Department of Transportation

MEMORANDUM

SUBJECT: ZC Case No. 19-01 – 1 Hawaii Avenue NE

Figure 1 - Site Plan (Source: Applicant's Pre-Hearing Statement)

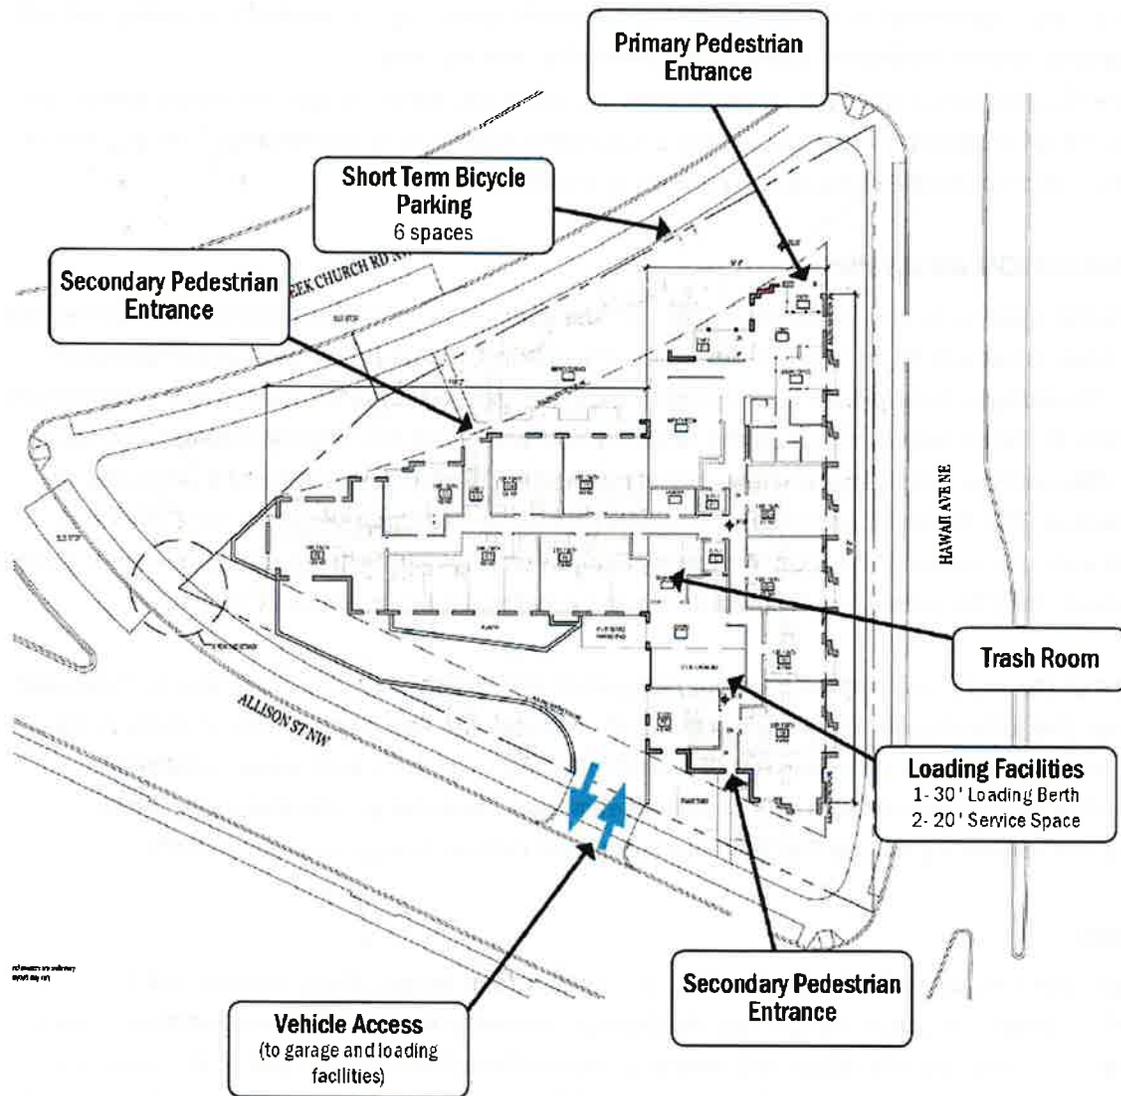
This triangular site is bounded by Rock Creek Church Road to the west, Hawaii Avenue to the east, and Allison Street to the south. Access to vehicle parking and loading is proposed from a curb cut along Allison Street consistent with DDOT standards for site access. Primary pedestrian access is located at the corner of Rock Creek Church Road and Hawaii Avenue and secondary access is proposed on Allison Street. Long-term bicycle parking is located in a bicycle room accessible via the parking garage. A site plan is shown in Figure 1.

- Utility vault location – Preliminary public space plans show an above-ground transformer on within the BRL area. An above ground transformer is considered a fixture and would likely require approval from the Public Space Committee. The Applicant should pursue other locations and treatments for the transformer possibly to include installing a utility vault or relocating the transformer in private property not subject to the BRL.
- Sidewalk within the BRL area – A portion of the surrounding sidewalks are shown within the BRL. The split of the sidewalk between ROW and BRL will require additional discussion at public space permitting. The Applicant may be required to redesign the streetscape such that the sidewalk is located entirely within ROW. Alternatively, legal agreements, possibly including an easement or ROW dedication, may be required.

- Playground within the BRL – The Applicant proposes a playground within the BRL on Rock Creek Church Road but has not provided plans showing the proposed treatment. Any playground equipment in this space would require approval from the Public Space Committee.

- Rock Creek Church wall and amenity terrace – A large amenity terrace and associated wall are proposed on Rock Creek Church. Walls are permitting within the BRL and in public space, but only when retaining natural grade. The proposed wall appears to include sections of free-standing wall and a glass panel and will need to be revised to come into compliance with public space regulations.

Final design of the public space will be determined during DDOT's public space permitting process. DDOT recommends the Applicant schedule a Preliminary Design Review Meeting (PDRM) prior to submitted for public space permits in order to discuss the proposed streetscape. Elements that will need to be further refined during the public space permitting process include:

Figure 5. Future Pedestrian Pathways (Source: Applicant's CTR)

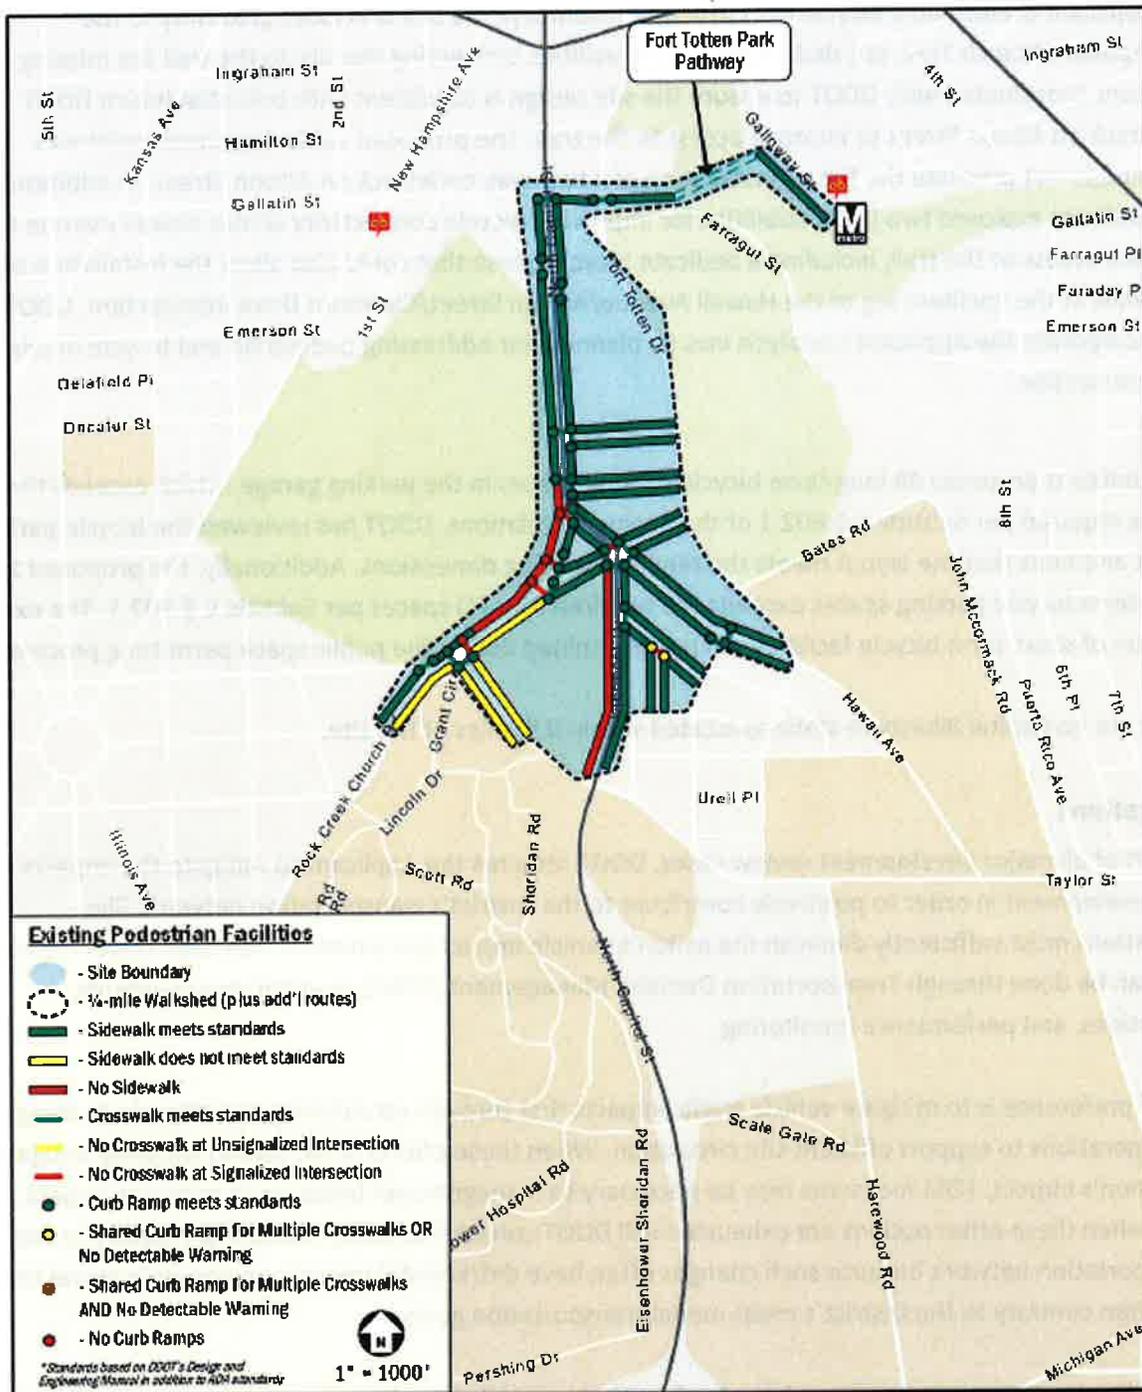
The Applicant preformed a sidewalk inventory in the vicinity (Figure 5). The inventory identified several gaps in network, however standard pedestrian facilities are largely present along the likely walking paths to transit stops/stations and destinations. Of note, there is no crosswalk on the northern leg of the

Hawaii Avenue/Allison Street/Clermont Drive intersection. Such an improvement would reduce the number of crossings needed to access the closest westbound/northbound H8 bus stop from three (3) to two (2). The Applicant explored two (2) possibilities for adding a crosswalk at the northern leg. As noted in the Bicycle Facilities section below, DDOT will use this analysis to inform its planning for pedestrian and bicycle improvements at this intersection.
